MAPLE MANOR, JSP 08-09

Public hearing at the request of J. S. Evangelista Development, LLC for Planning Commission's recommendation to City Council for revised Concept Plan associated with a previously approved zoning map amendment with a Planned Rezoning Overlay (PRO), and approval of Preliminary Site Plan and Storm water Management Plan, subject to the City Council's approval of PRO Concept Plan. The subject property is located in Section 2, at the southwest corner of Fourteen Mile and Novi Road on 3.88 net acres. The applicant is currently proposing to add an exterior storage garage and a pavilion/gazebo area to serve their existing convalescent (nursing) home building.

PLAN REVIEW CENTER REPORT

PRO Concept Plan Amendment

SHEET
Concept Plan

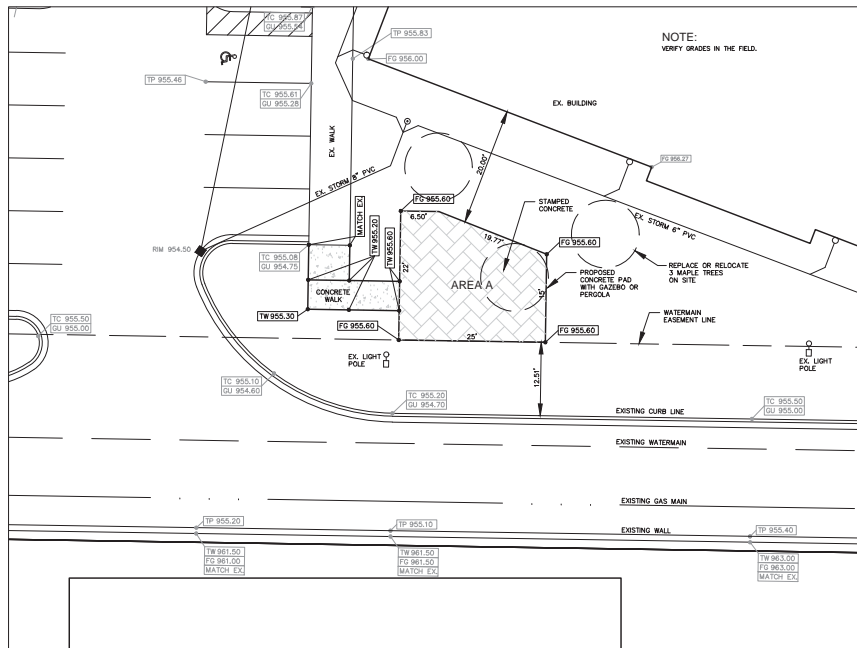
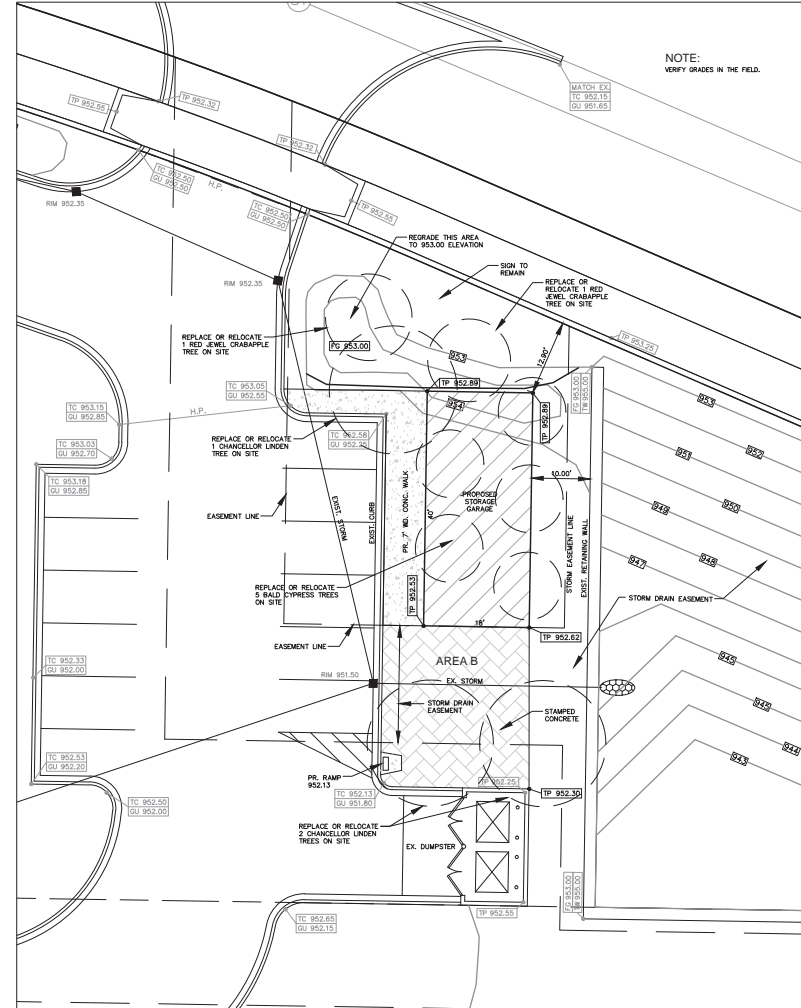
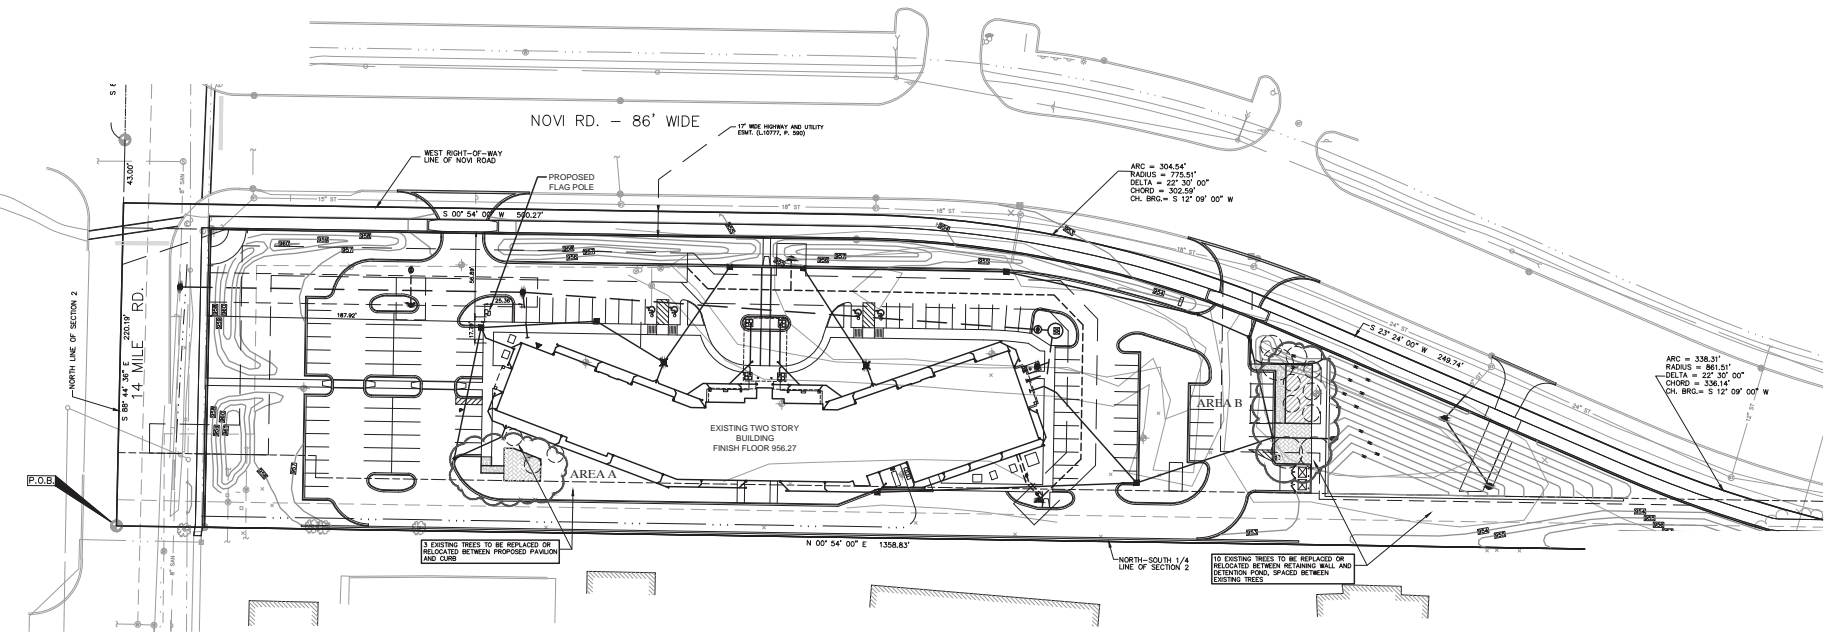
1. **Location (Sec. 4.19.1.B)** *Accessory buildings shall not be erected in any required front yard or in any required exterior side yard. **Proposed storage garage is located partly in the required front yard. According to applicant's cover letter, the needs for storage are crucial and this is best possible location for a storage garage within the site that has a minimal deviation from the ordinance and does not conflict with the Utility locations and easements. This deviation requires City Council approval and should be included in the revised PRO agreement.***

3. **Total Floor Area (Sec. 4.19.1.C)**: *The total floor area of all accessory buildings shall not occupy more than twenty-five (25) percent of any required rear yard. **The plans appear to be in conformance. Please provide the values on the site plan.***

4. **Maximum Height (Sec. 4.19.1.B)**: *A detached accessory building in the R-1 through R-4, RT, RM-1, MH, OS-1, B-1, P-1, and NCC districts shall not exceed one (1) story or fourteen (14) feet in height. **Provide the maximum height of the structures on the plan***

5. **Building Design (Sec. 4.19.2.L)**: *All attached and detached accessory buildings in excess of two-hundred (200) square feet shall be designed and constructed of materials and architecture compatible with the principal structure, and shall have a minimum roof pitch of 3/12 and overhangs of no less than six (6) inches. **Refer to Façade review letter for more detail. Add a note to the storage garage elevations that the materials will match the existing building.***

7. **Lighting:** There is no proposed lighting indicated on the plans. Please verify if any additional lighting is proposed for the proposed structures. A proposed photometric plan conforming to the ordinance requirements is required prior to the approval of Final Site Plan.
8. **Other Reviews:**
 - a. **Engineering Review:** Additional comments to be addressed with revised submittal. Engineering recommends approval.
 - b. **Landscape Review:** Additional comments to be addressed with Final Site Plan submittal. Landscape recommends approval.
 - c. **Facade Review:** Additional comments to be addressed with Final Site Plan submittal. Façade recommends approval.
